TREMONT CROSSING

Response to Request for Supplemental Information Supplemental Draft Project Impact Report

Re: Tremont Crossing: Draft Project Impact Report- Request for Supplemental Information

Figure 4-16: Neighborhood Plan

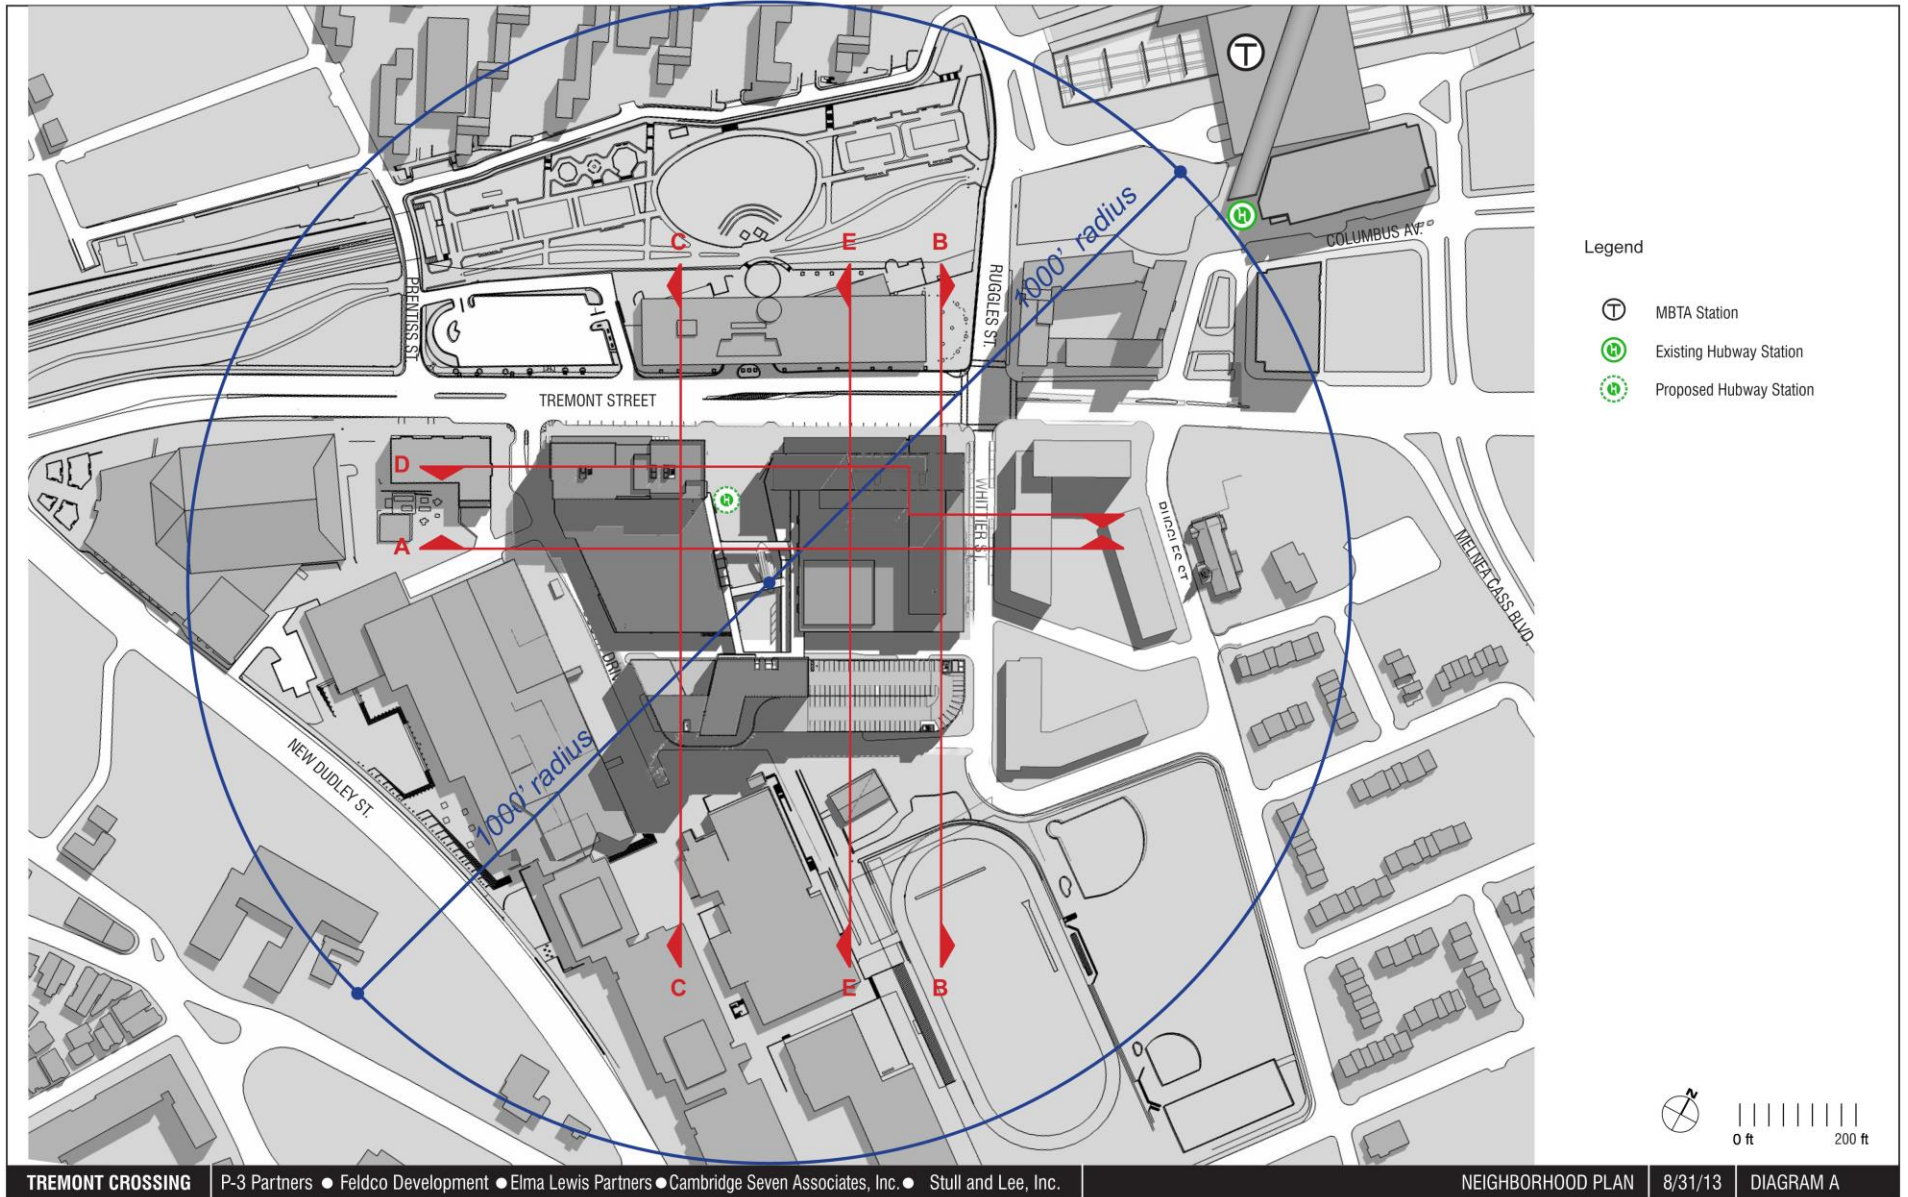
- BRA 29 Provide neighborhood plans at a scale of 1" = 100' extending not less than 1,000 feet in all directions.**
- Please see Figure 4-9: Neighborhood Plan (Section 4.2).
